# 1977 Corvette: Service Bulletin: Anti-Theft Alarm System Interim Modifications

**Source:** Chevrolet Dealer Service Bulletin

**Bulletin No:** 77-I-38

**Date:** May 1977

FIGURE 1

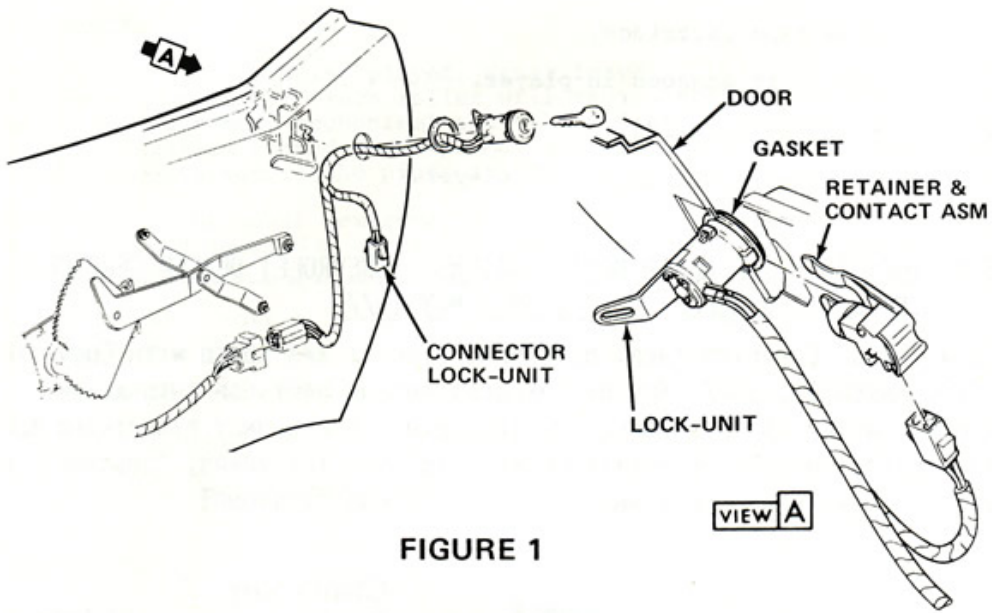
- The actuating switch for the system is no longer located on the left front fender. It has been incorporated into the left front door lock and must be activated by locking this door with the key from outside of the vehicle (Figure 1). This is the only way the alarm can be set. Turning the inside door knob to the locked position when exiting the vehicle will not activate the alarm system.
- The anti-theft alarm system horn has been moved from the left rear inner fender to the far left side of the engine compartment dash panel. (Figure 2).
- The anti-theft alarm system flasher assembly is now located on the console trim plate (Figure 3), rather than the rear compartment underbody panel.
- The new anti-theft alarm system wiring diagram is illustrated in Figure 4.
